**6614C-07A**

# S E R V I C E N O T E

## Agilent 6614C DC Power Supply

**On faster computers, when programming over GPIB, a random error will occur.**

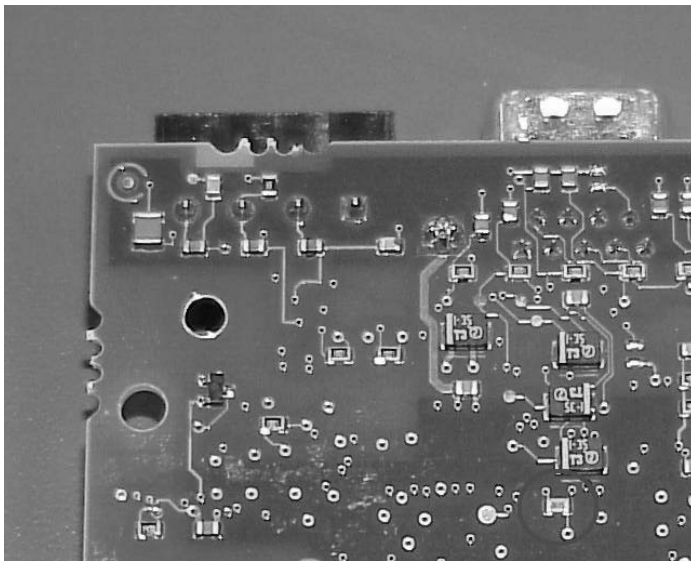
When programming a unit over GPIB, a random error -113 (“Undefined header”) will appear on the unit. This error can be read back via the front panel or over the GPIB bus.

Change resistor R1246 (see picture for location) from 511 Ohms to 100 Ohms (part number 0699-3058). This requires un-soldering and soldering a surface mount component and can be very difficult. This does not require re-calibration.

Replace the entire GPIB assembly (part number 5063-4841) with a newer one that has the 100 Ohm resistor. This will require the unit to be re-calibrated.
